**FACILITY CONDITION REPORT: 250M CAPACITY - ELEVATED POTABLE WATER TOWER**

**MANGUM, OK - DOWNTOWN TOWER**

Potable Water Storage Tower (Location: Downtown Mangum, OK - Pigg St & Commerce)

12/14/2024 – Inspector: Alek Gray

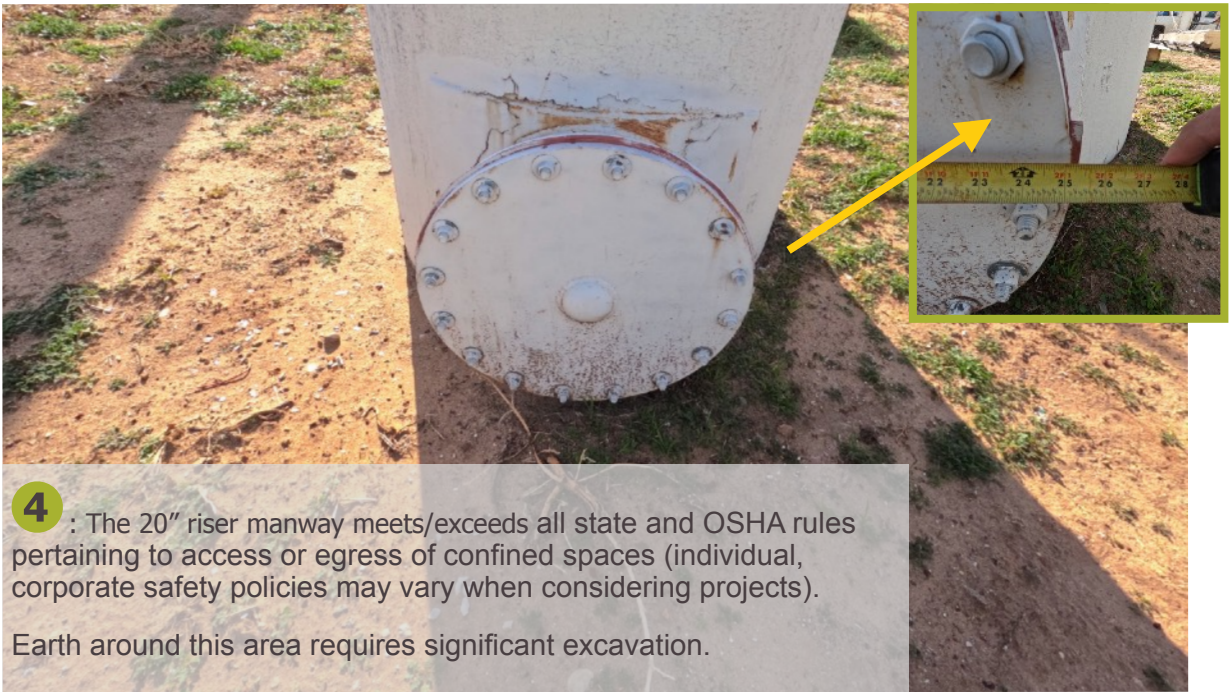
**2** : Observable surfaces of the tower's concrete foundations were noted in poor condition with spalling and cracks along exposed areas of the foundations.

**3** : Earth around the concrete foundation was noted not properly excavated as earth has accumulated over foundation pads.

**4** : The 20" riser manway meets/exceeds all state and OSHA rules pertaining to access or egress of confined spaces (individual, corporate safety policies may vary when considering projects).  
Earth around this area requires significant excavation.

**5** : The roof hatch construction and design does not satisfy state rules. The hatch was discovered unsealed at the date of this inspection. Surface water and insects may easily infiltrate the tank.

**6** : The tower's 6", interior overflow extends from beneath the ground, and is protected with a screen (see specific standard on the final page).

The overflow extending inside the tank can be seen in the lower inset photograph to the right.

This overflow will likely need to be fully replaced as properly preparing the interior surfaces of the riser behind interior overflow is unlikely.

**7** : The old finial ball used for the rolling ladder to swing around has been drilled for a secondary use as a vent. This finial ball will require removal and replacement with a proper, designated vent.

**8** : The exterior, fixed ladders are not equipped with any fall protection system as required by OSHA. Note in the above photograph, temporary repairs being performed by inspection crew. The roof ladder is a rolling ladder. The roof and shell ladders will need to be replaced and/or relocated and properly attached as required (rolling roof ladders are not allowed by OSHA). See photograph of interior ladder on page 13. This interior ladder is unsafe for any use by any personnel!

The leg ladder has been covered in telecom coax. All coax must be removed from the handrail of the ladder. This is seen to the left.

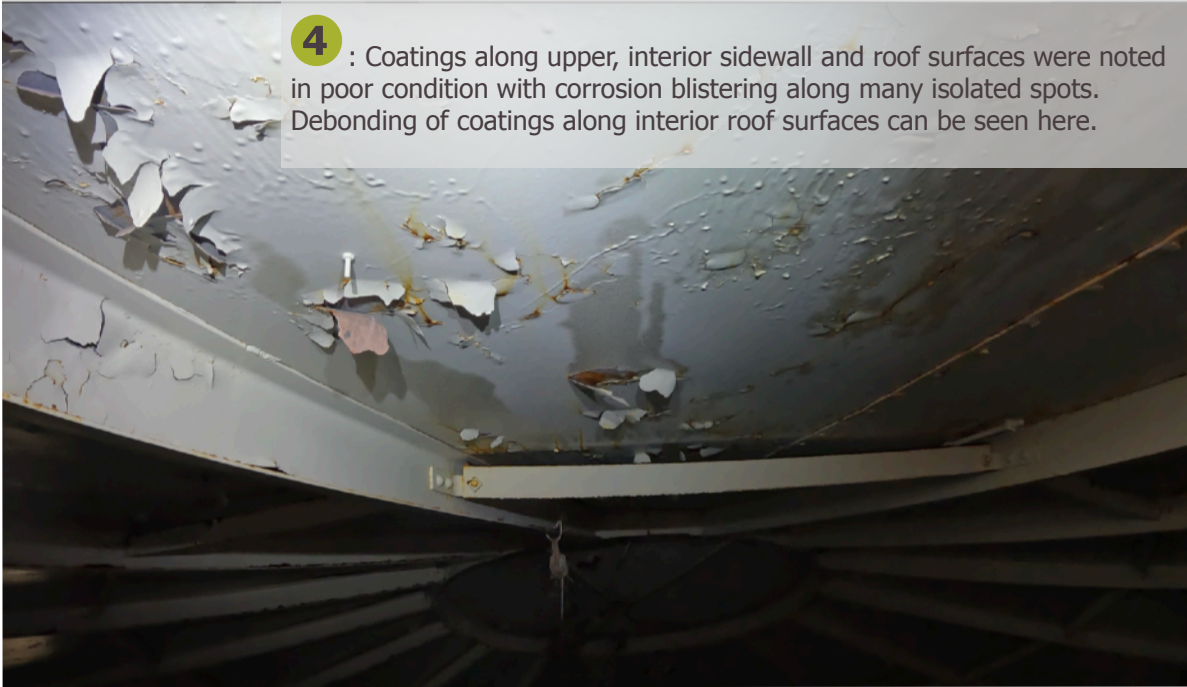
**1** : Coating condition seen here, along the roof. Widespread debonding of the coatings all the way past the original coatings, to the steel substrate. This strongly indicates that the tower has been overcoated too many times creating excess wight.

**2** : Coatings condition along the upper shell and roof eave.

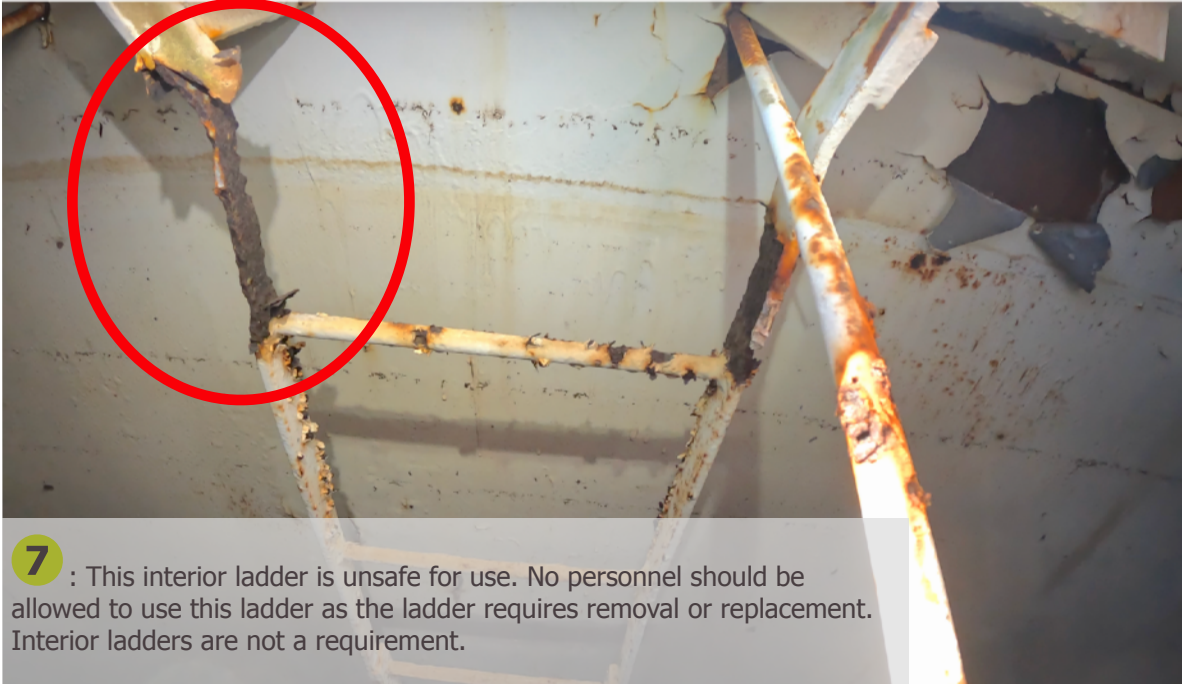
**4** : Coatings along upper, interior sidewall and roof surfaces were noted in poor condition with corrosion blistering along many isolated spots. Debonding of coatings along interior roof surfaces can be seen here.

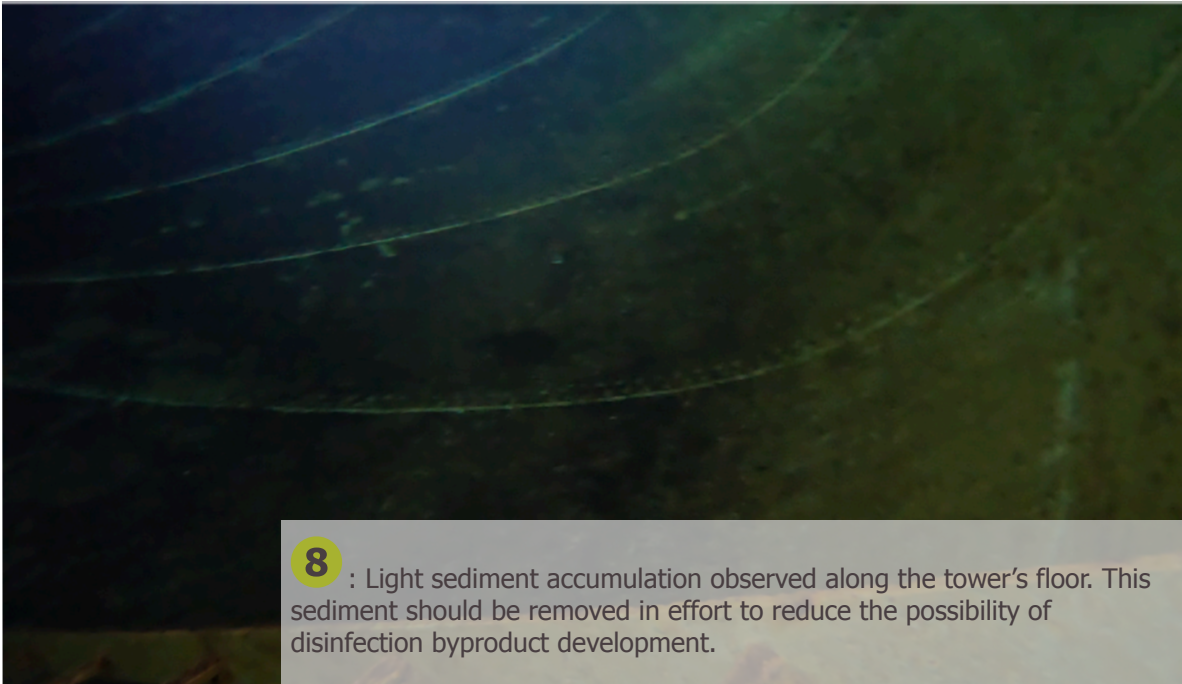
**5** : These rods seen here are the tower's original spider rods used for part of the rigging for the tower's construction. They are no longer necessary, and should be removed along with caulking the roof's lap joints and the opening between the roof and the sidewall seen here.

**7** : This interior ladder is unsafe for use. No personnel should be allowed to use this ladder as the ladder requires removal or replacement. Interior ladders are not a requirement.

**8** : Light sediment accumulation observed along the tower's floor. This sediment should be removed in effort to reduce the possibility of disinfection byproduct development.
